Remarks/Arguments

The specification is amended at paragraph [0012] to better conform to the official translation and to clarify the description of gap 18 as shown in Fig. 1 and its relationship to the plate 34 (Figs. 1 and 2):

Fig. 1

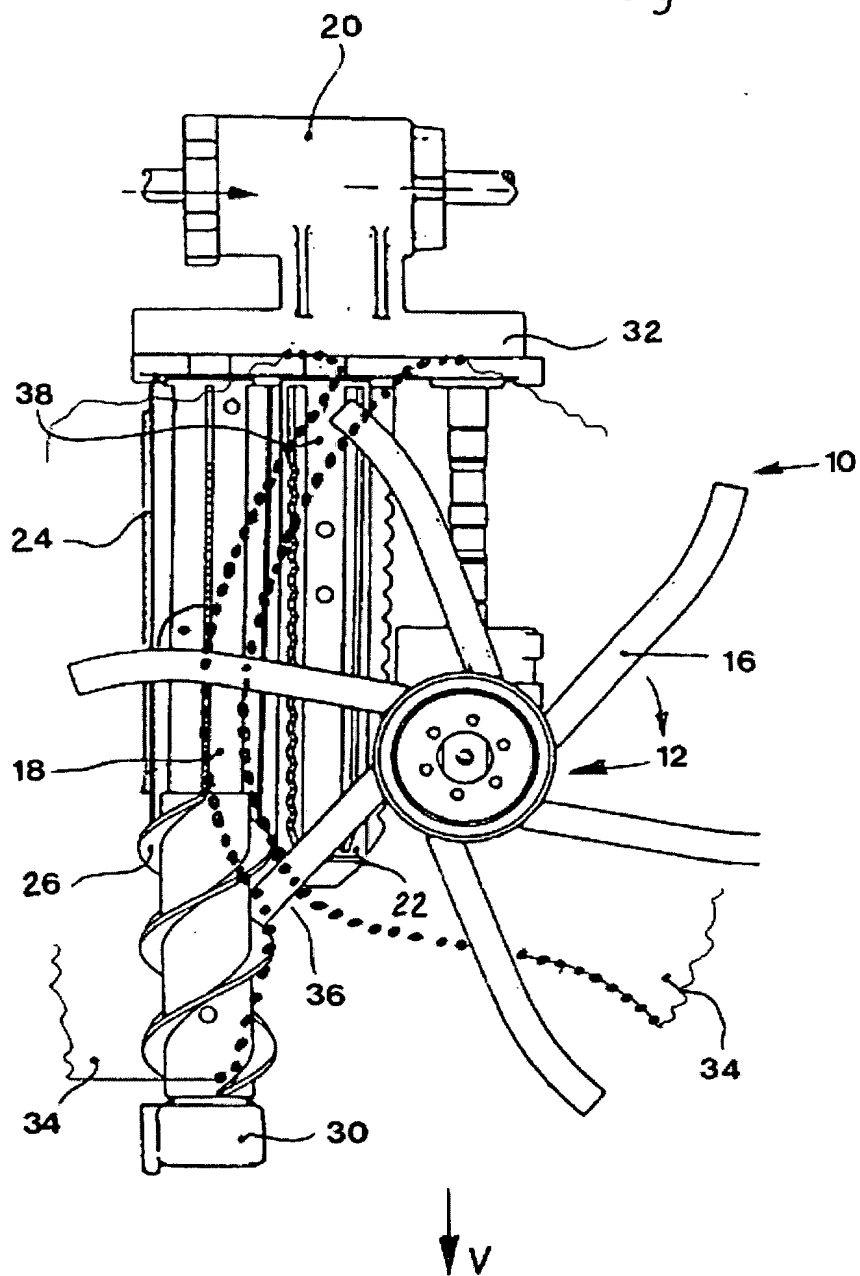
It is stated in the Detailed Action that Figure 1 merely shows dotted lines as defining the picking gap. Although solid and broken lines are not shown in the Figure to indicate open and hidden components, etc., there can be no doubt in the mind of observer that the gap is clearly shown and highlighted by the dotted lines. The picking gap 18 is a curved gap in the plate 34. The portions of the plate 34 on both sides of the gap 18 are shown in Fig. 1, and the location of the plate 34 is shown in Fig. 2.

A new drawing figure is attached to replace the original Figure 1 to add broken lines, etc., to more clearly designate open and hidden components. No new matter has been added since the corrections are supported by specification, claims and original Figures 1 and 2 as filed. Please note the location of the plate 34 in Figure 2 and the descriptions set forth herein above.

“The picking gap 18 is ~~defined by~~ provided in an approximately horizontal stripper plate 34 that is arranged beneath the fingers 16 and above the picking rolls 22 and 24.”
